907 NW MARKET ST

RECOMMENDATION MEETING
NORTHWEST BOARD | 02/07/2022
3036107-LU

EARLY DESIGN GUIDANCE RESPONSES |
MASSING OPTIONS & DESIGN CONCEPT

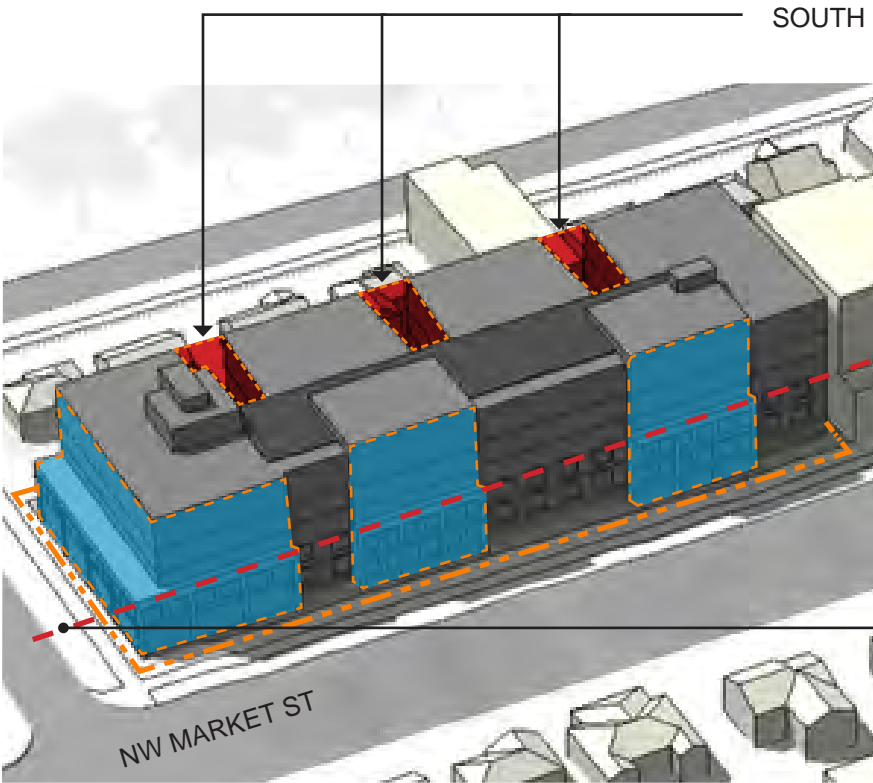
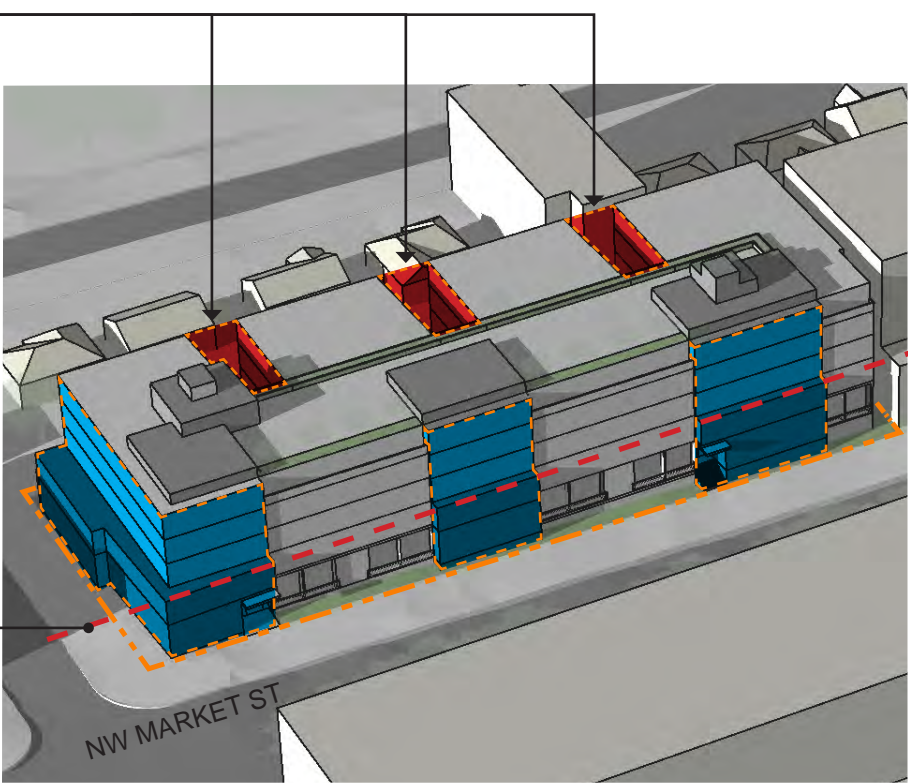
BOARD GUIDANCE |
a) The Board generally supported the changes to the north facade of Option A shown within the EDG 2 packet. The supported changes include the legible rhythm of projecting and recessed elements, the coordination of secondary elements like entries and balconies within the facade design, and the alignment of facade setbacks with the locations of street trees along NW Market Street.

BOARD GUIDANCE |
b) The board supported the reduction of the podium scale in Option A which reflects the residential character of the surrounding area.

APPLICANT RESPONSE |
The proposed design reflects a refined evolution of massing Option A and the provided conceptual sketch from the EDG 2 presentation. The rhythm of the alternating recessed and projecting masses in response to the existing street trees, private deck activation at street level, and multiple entries have all been retained as part of the proposed design.

APPLICANT RESPONSE |
The two-story podium at the northeast corner as presented at the EDG 2 presentation has continued to evolve but maintained the traits the board appreciated from the preliminary massing and design. The masonry volumes are expressed as distinct masses, to establish a primary pedestrian realm organizing/hierarchical element. The brick volumes organization with unique transparent corners and punched windows reflect the residential character of structure, in contrast to a more commercial “pilaster frame” expression shown in earlier studies. Steel accents, deck railings, and warm accent colors at the entries add human scale and visual interest to the streetscape. These elements are repeated at the base of the protruding bays along the north facade, including the secondary west entry to mitigate the building mass facing Market Street.

COURTYARD CONCEPT PLAN

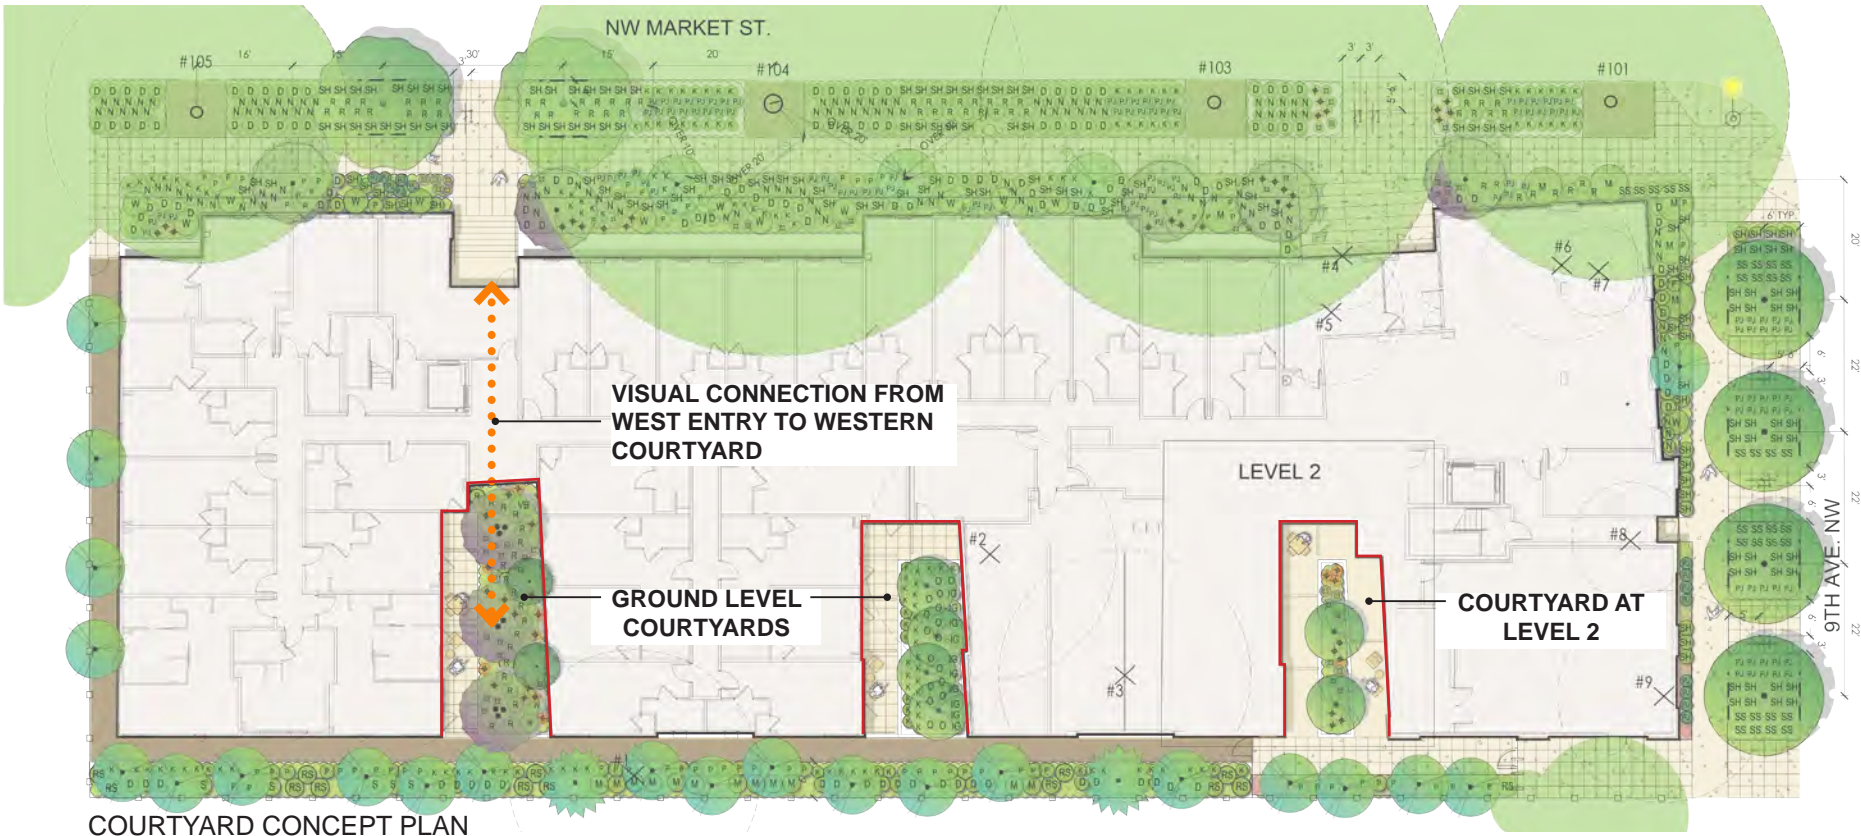
a) The Board supported the width and depth of the courtyards for the purposes of creating an appropriately scaled zone transition. However, the Board reiterated its livability concerns from the first EDG, related to the effect of the courtyard widths and privacy and access to light for the residential units along the courtyards. The Board requested the following information at the Recommendation phase to address these concerns:

- i. Detailed information related to unit proximity and window patterns within the courtyards showing that privacy will be maintained among units.
- ii. Additional study showing the availability of light to residential units, especially for those located within the deepest parts of the courtyards.

b) While supporting the proposed intent for large tree plantings within the courtyards, the Board expressed concern that insufficient light into the courtyards would inhibit their growth. The Board requested additional information at the Recommendation phase showing how trees can thrive within the courtyard spaces.

c) The Board supported the alignment of the westernmost courtyard with the secondary lobby along the NW Market Street frontage as a method to visually connect it to the interior spaces and the street frontage.

The courtyards along the south facade have maintained the increased width and reduced depth from the EDG 2 presentation. The interior program has also been reorganized to maximize opportunities for light and air to the residential units. At the western courtyard, the direct connection with the west lobby and corridor has been retained, while the central and east courtyard units have been situated at the south end of the courtyard, allowing those units to get additional light and air while also reducing the number of units with fenestration facing each other, alleviating privacy concerns. Studies of window patterns and privacy can be found on page 44.

The depth of the courtyards have been reduced to mitigate the board’s concern about insufficient light within the courtyards. The landscaping in the courtyards has been carefully selected and coordinated to provide a design and palette that will thrive within the provided light conditions.

The direct visual connection from the west entry stoop, through the lobby to the westernmost courtyard has been maintained, and the width and alignment of the lobby further refined to take full advantage of the connection. The visual connection and access to light and air has also been preserved at the upper levels, allowing light from the southern courtyard to spill into the corridor and provide a small-scale communal amenity at each level.

REQUESTED DEPARTURE #1

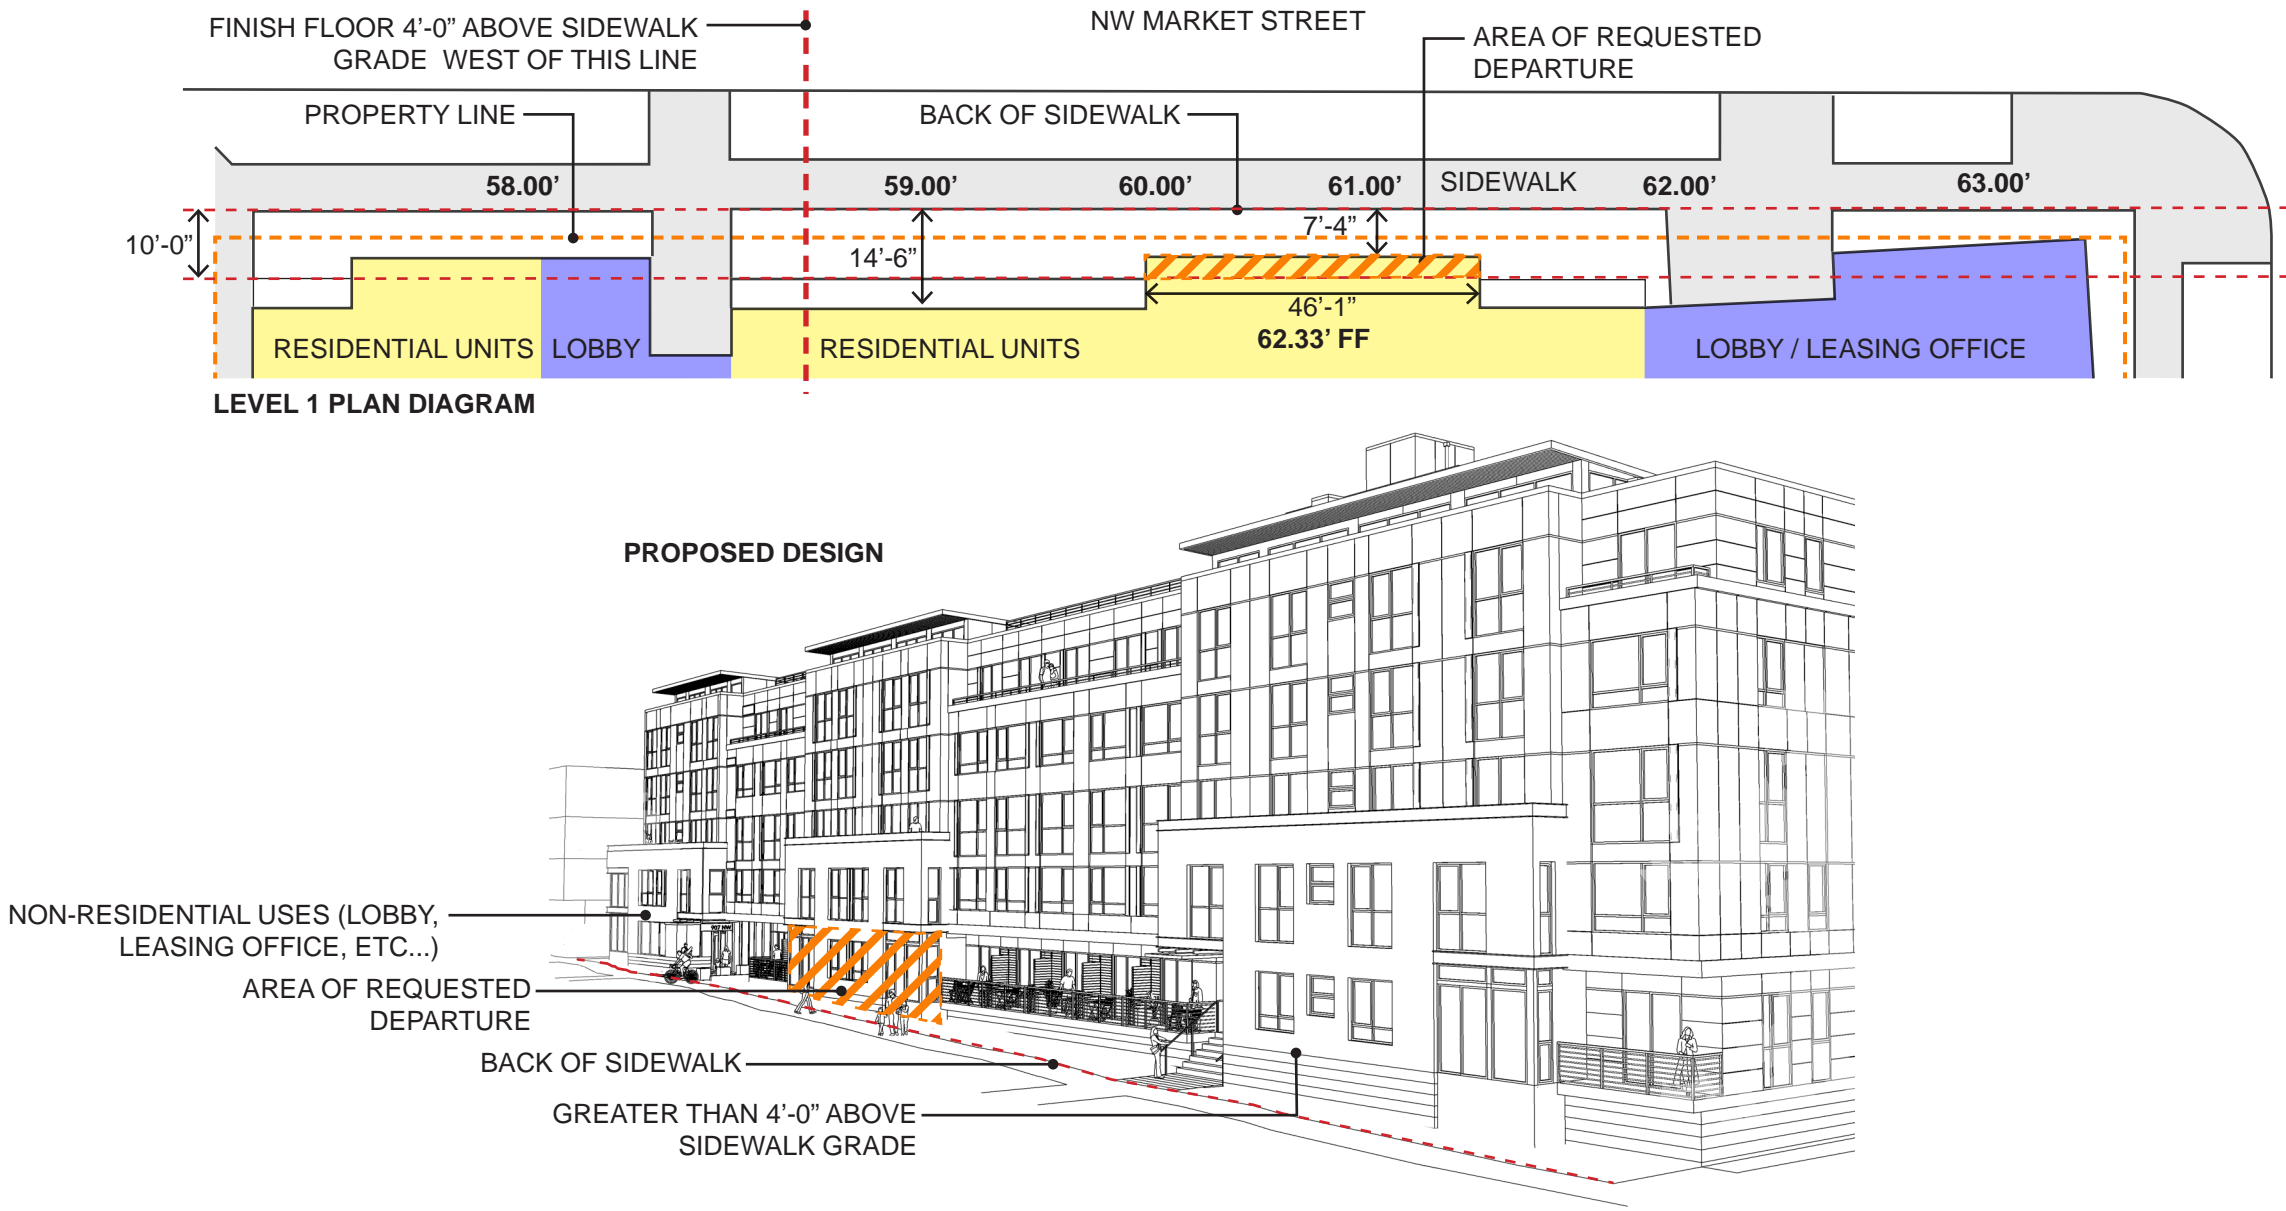
Along Market Street, the structure is modulated, with most of the ground level frontage set back approximately 14'-6" feet from the sidewalk, however three (3) two-story volumes extend out to within 7'-4" of the sidewalk. The western volume contains common uses - entrance, lobby, and leasing office. The other two volumes contain residential units, however due to the sloping topography along Market Street, only the central volume is within 4'-0" of sidewalk grade.

A departure is requested for this portion of the structure containing 4 units is located 7'-4" from the sidewalk and approximately 1'-7" to 2'-8" above sidewalk grade.

- The combination of being both elevated above and set back from the sidewalk creates a semi-private space between the residential units and the pedestrian realm. (PL3.B1,PL3.B2)

- The establishment of street-level private amenity space provides activation to the pedestrian realm and encourages interaction between residents and the neighborhood. (CS2.D2, PL1.A2, PL2.B1, PL3.B4)

- Strict code compliance could be maintained by stepping the building up to attain the 4'-0" grade change, however due to the sloping topography of the site it would create steps and/or ramping within the building or at the primary entrance on the corner, hampering the accessibility for residents and weakening the connection to the sidewalk. (PL2.A1, PL1.B1)

- The modulation pockets align with the location of the large street trees, providing additional relief to the root and canopy of the tree and assisting in their preservation and vitality during and post construction (CS1.D1, CS2.D2)

REQUESTED DEPARTURE #2

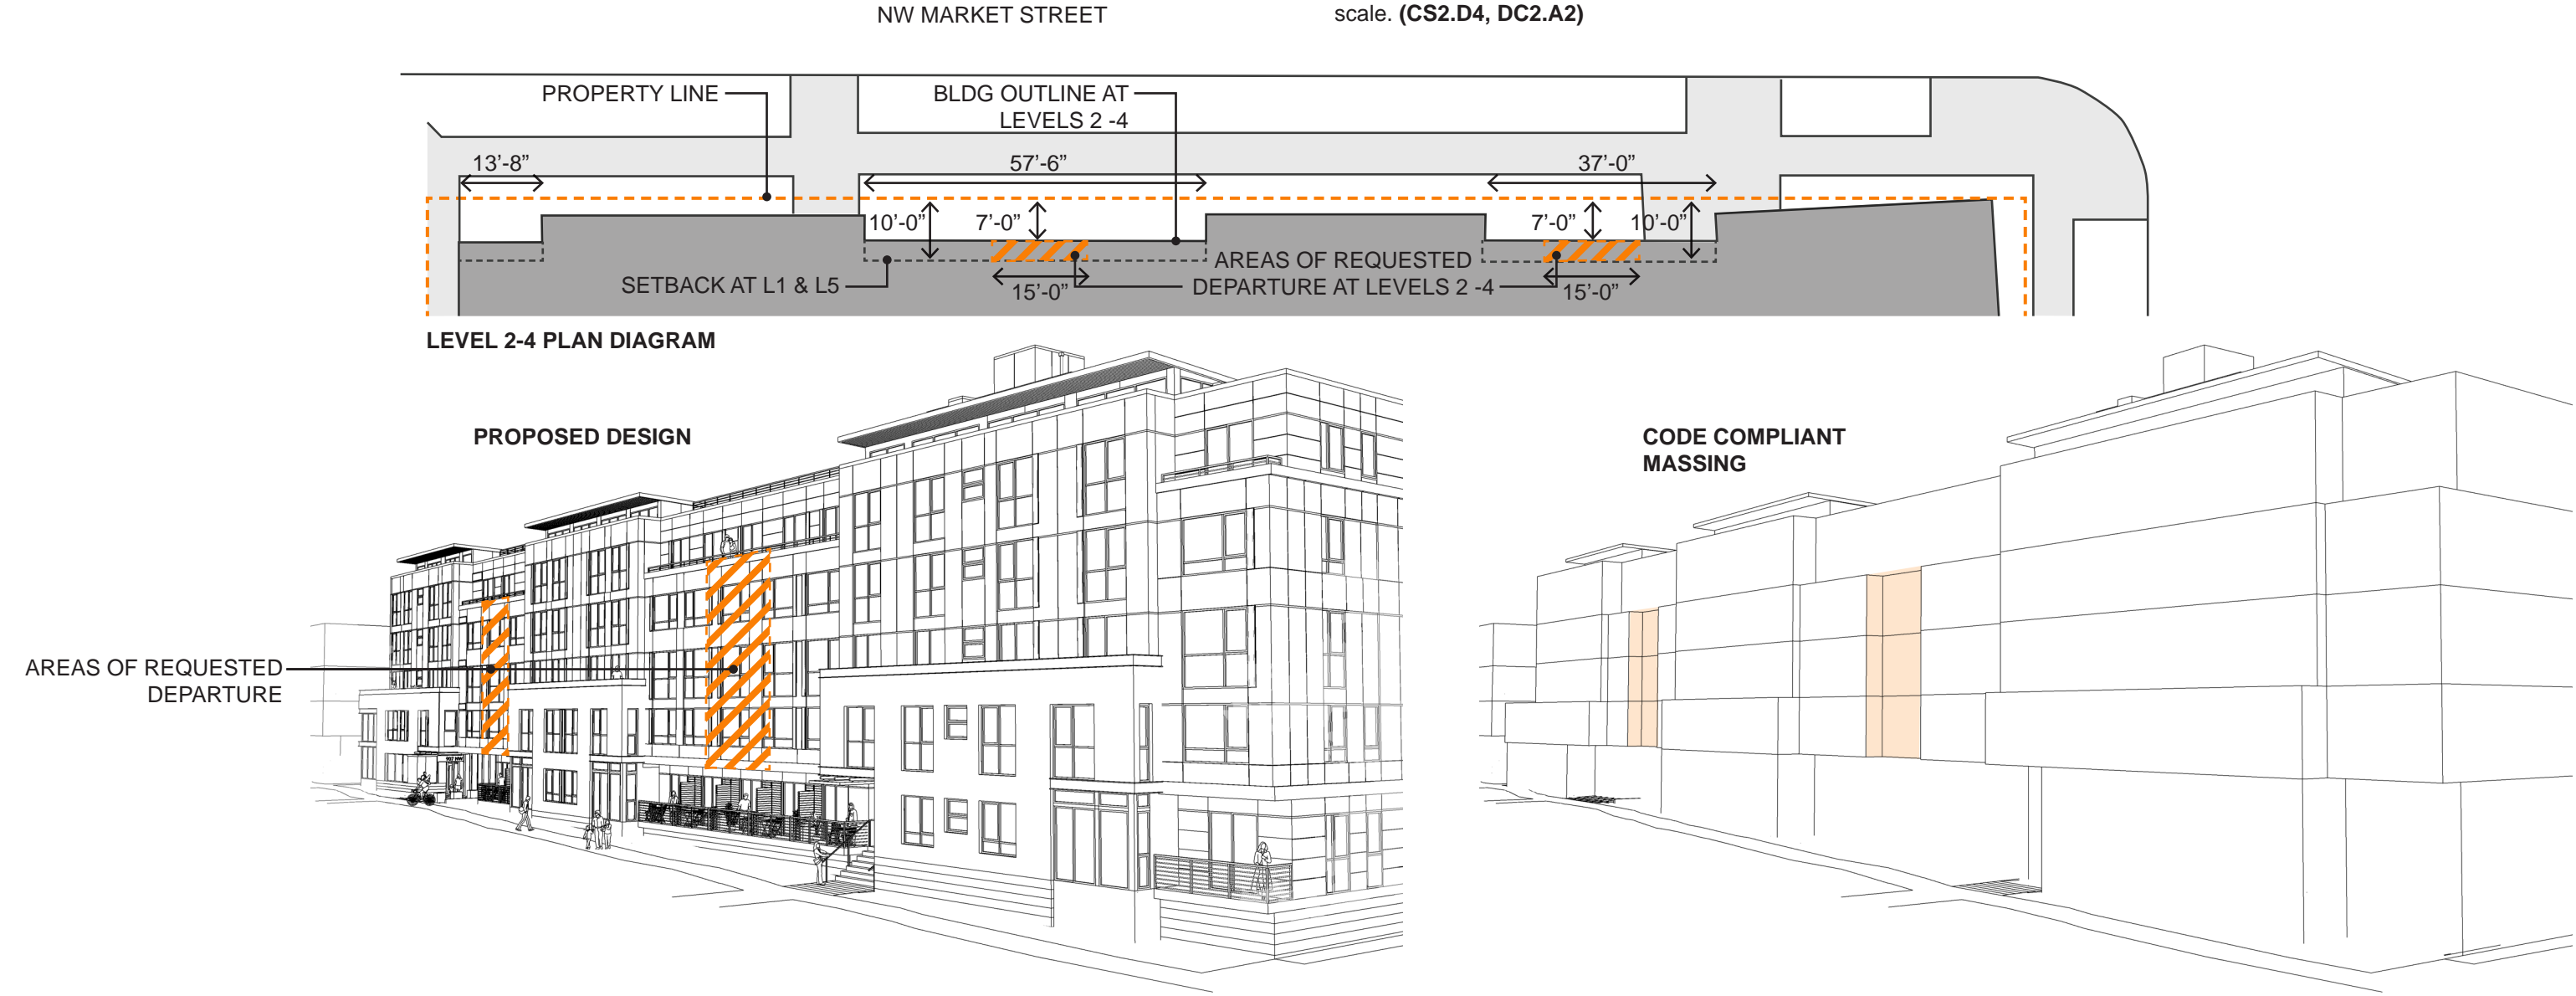
The facade is modulated, per the 100 foot maximum length requirements with recesses that are also compliant in length (> 15'-0"), and depth (> 10'-0") at levels 1 & 5, but do not meet the 10'-0" depth requirement (7'-0") at levels 2 - 4.

A departure is requested for the modulation depth to be 7'-0" instead of 10'-0" at levels 2 - 4, with the width of the recessed portions greatly exceeding the 15'-0" minimum width.

- Strict compliance with the code could be maintained by recessing two 15-foot wide portions an additional 3 feet, however this would reduce the legibility of the board-preferred design parti, as well as further complicating the massing for a building of this scale and size. Further articulation of the building mass is more appropriately established through the provided secondary elements, materials, and street-level details. (DC2.A2, DC2.B1)

- Similar scale projects along Market(AVA & Koi apartments) do not provide upper level setbacks or significant modulation, instead favoring a simple, unified massing approach. (CS2.A1, CS3.A2, DC2.C3)

- The setbacks and modulation as proposed successfully meet the intent of the design guidelines to mitigate the bulk and scale of the long facade as greater than required setbacks are provided along the street frontage and the recessed portions exceed the required 10 foot setback when measured from the sidewalk location. (DC2.A2)

- The depth and location of the modulation is a site-specific response to the tree preservation and powerlines along NW Market Street. (CS1.D1, CS2.B1, CS2.D2)

- The robust landscape buffer from the back of walk to the structure edge further mitigates the structure's height, bulk, and scale. (CS2.D4, DC2.A2)
